RE: CPU CU 21-00046 and AR WR 21-00195

Almagre Community Housing 3725 Verde Dr / 1609 Zebulon Dr

PUBLIC COMMENT/RESPONSE

Addendum C

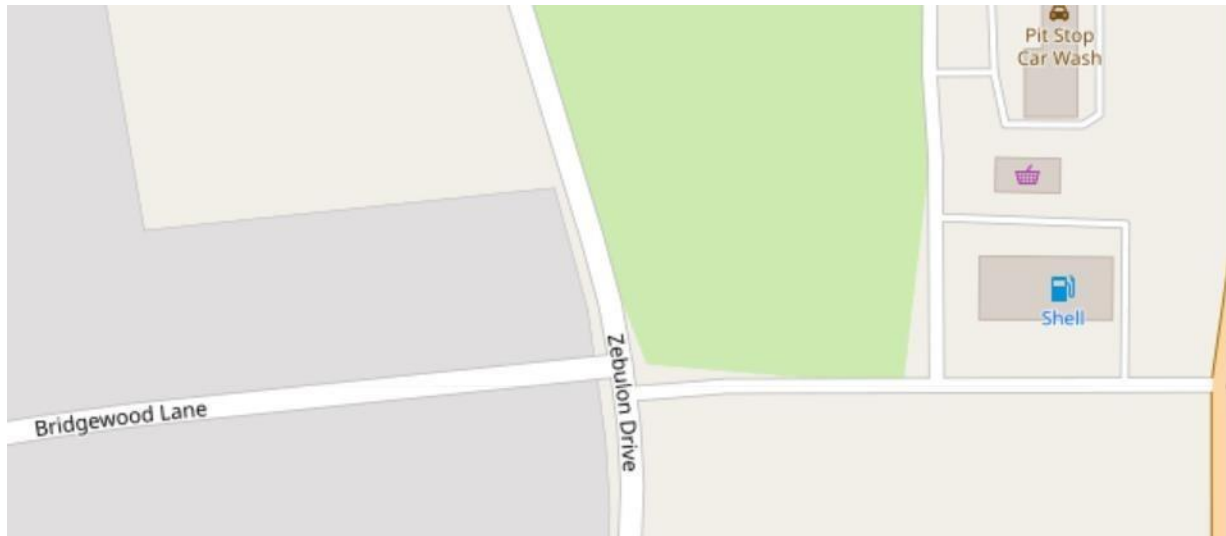
View of current access, business & application site:

Addendum E:

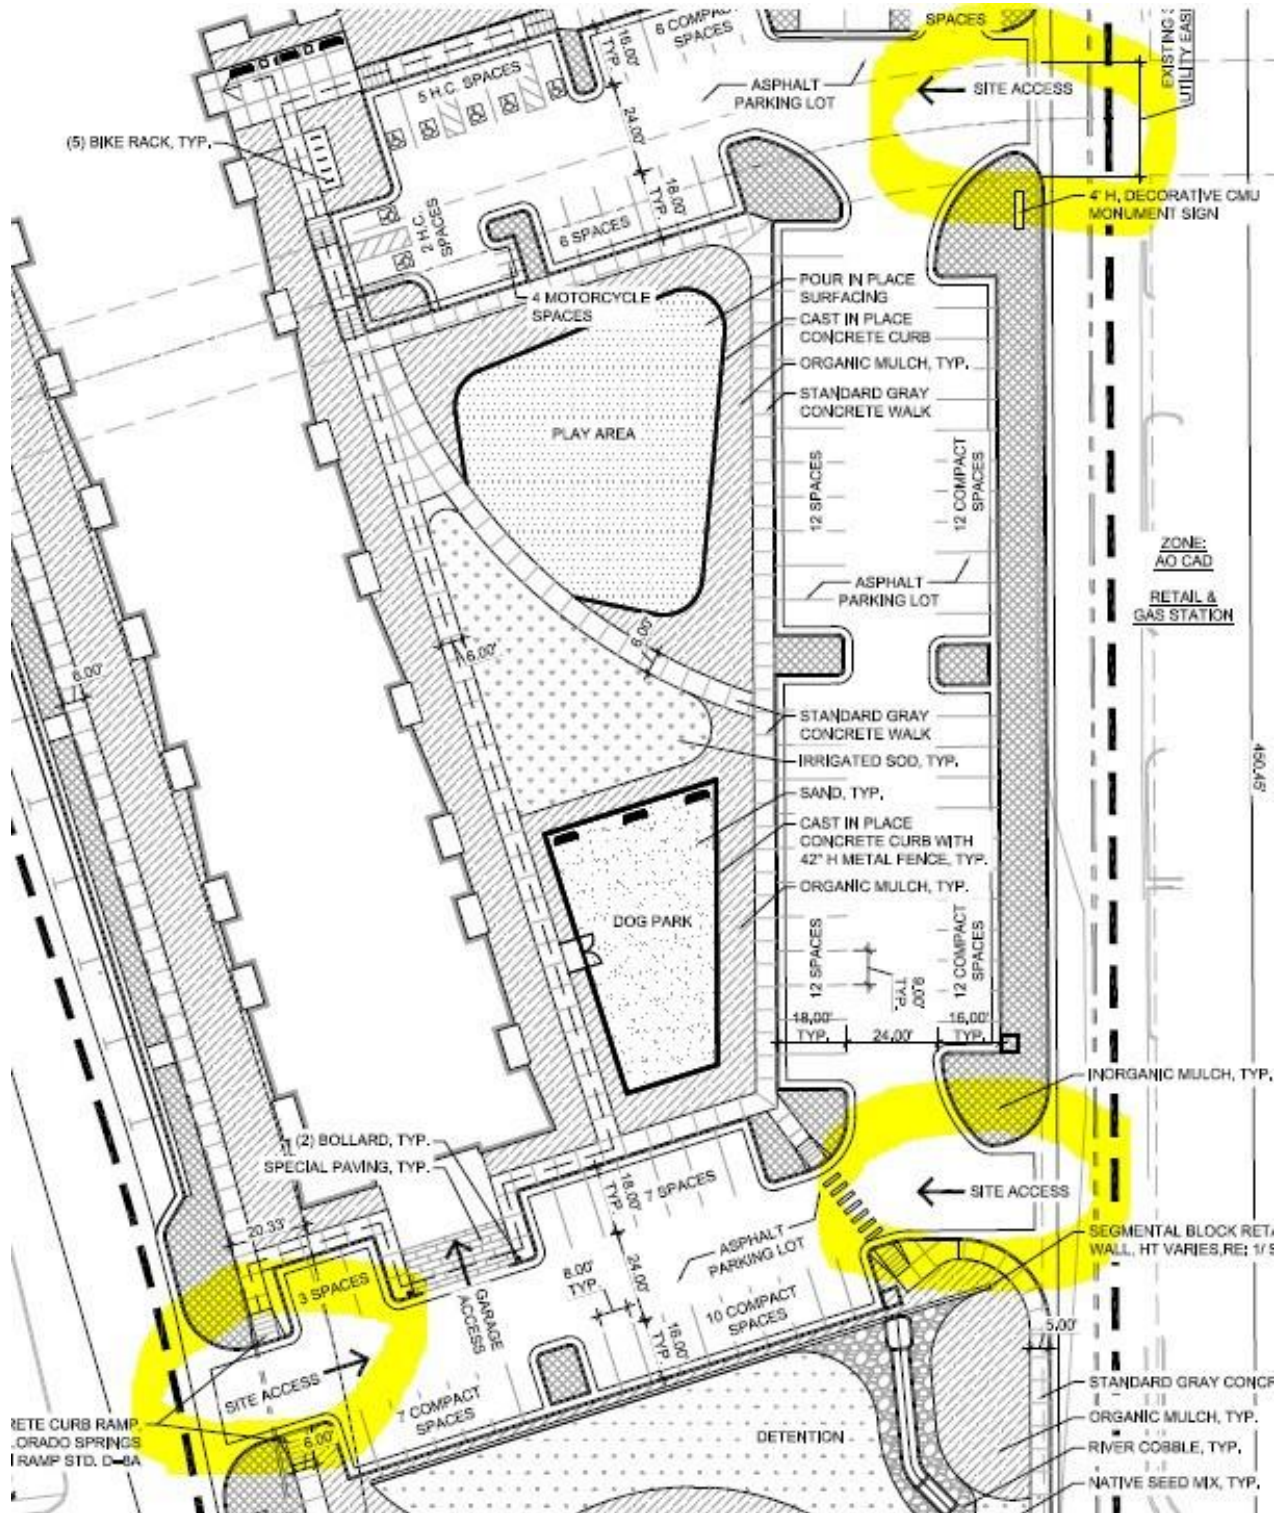
Traffic study, page 6 (3) map: Shows “Access A” from Zebulon directly into apartment site. It also shows “Access B” from apartment site via internal commercial access road. Development plan, page 3: shows a third access at the southeast corner that is not referenced in other drawings.

See addendum E Yet a fourth access is show on page 20 of the Geological study. See addendum F.

Development Plans shows 3 access points for housing

Response: Please note, geological studies are conducted within early evolving planning stages. Site access is correctly reflected in development plans.
